FINAL
ENVIRONMENTAL IMPACT REPORT
MBTA ALEWIFE STATION
INTERIM ACCESS

EOEA #4931

PREPARED FOR
MASSACHUSETTS BAY TRANSPORTATION AUTHORITY

This Final Environmental Report summarizes the Alternatives analysis process, describes the preferred alternative in detail, and responds to comments made on the Draft Environmental Impact Report.

Figure V-A

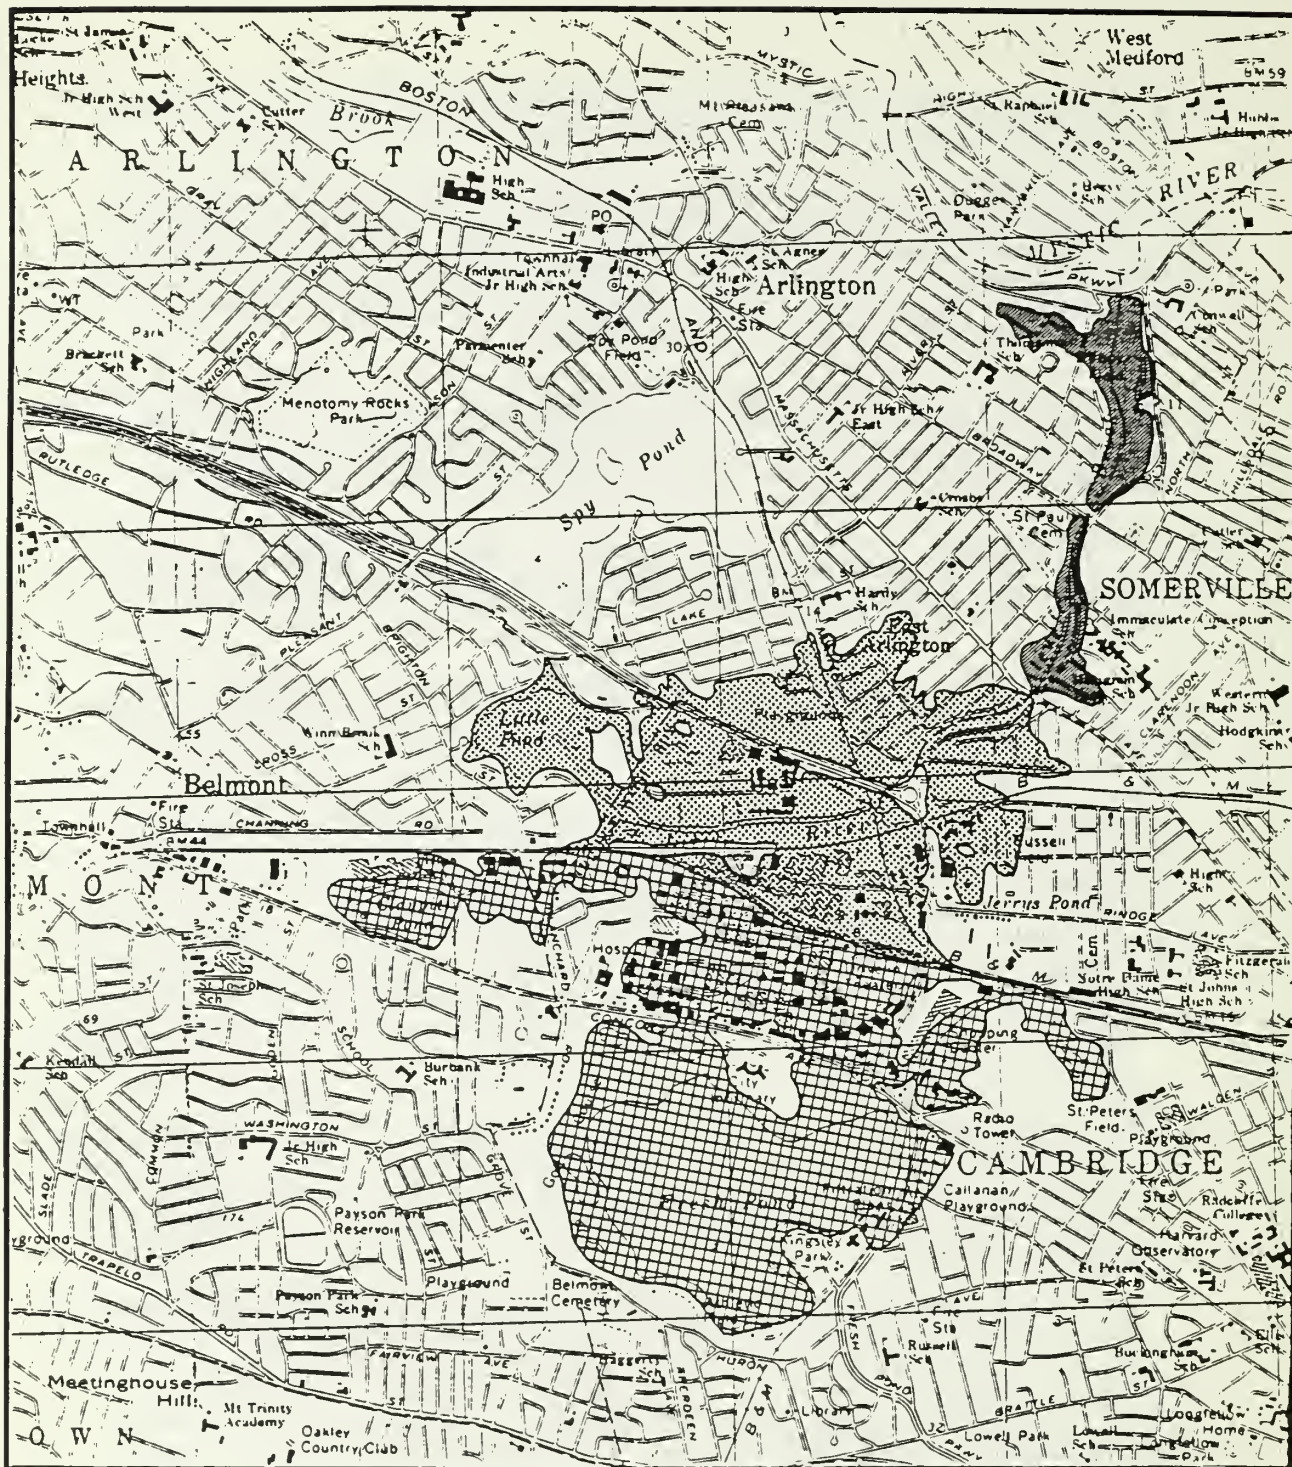
A-16 Comment: "The floodplain map on page V-B does not show the full extent of 100-year flooding. The Final EIR should also include a Figure V-G showing the 100-year elevation for the triangle and MBTA station area. Information from the ADL Draft EIR (EOEA #4957) should be utilized, along with suitable mapping to show the floodplain area and representative flood water depths at proposed ramp locations. Note that the ADL EIR estimated the 1955 flood of record to be a 30-year event, rather than a 100-year storm, with flood elevations of 6.9 USGS. However, the Interim Access EIR indicates the 1955 flood elevations were 7.4 on the USGS datum. The Final EIR should resolve these discrepancies."

Response: The basis of the flooding calculations used in the DEIR are the Resources Analysis report for Alewife Station and the Camp, Dresser and McKee report for the Mystic River. These reports have been the basis of all the Red Line work at Alewife and have been accepted by all regulatory agencies.

A copy of Figure 3-15 from the ADL DEIR showing the 100-year floodplains for the Alewife area is attached as Figure V-A.
